# Computer Monitors Service Bulletin

### Model: GDM20SE1

## No. 77

Subject: Preventive Measure to protect R-850

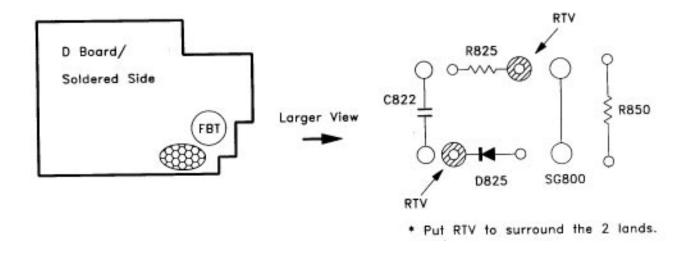
- (111) Possible Shut down
- **Solution:** To prevent the possibility that R-850 on the D-Board will open, perform the following circuit change:
  - 1 Replace C-822 with the following new part.
  - 2 Replace R-850.

3 Apply RTV to the lands indicated by stripes in the figure below:

REF	NEW	
	DESCRIPTION	PART NUMBER
C-822	CAPACITOR (1000V, 470PF)	1-162-134-11
R-850	RESISTOR (4.7K, 1/2W)	1-202-826-00
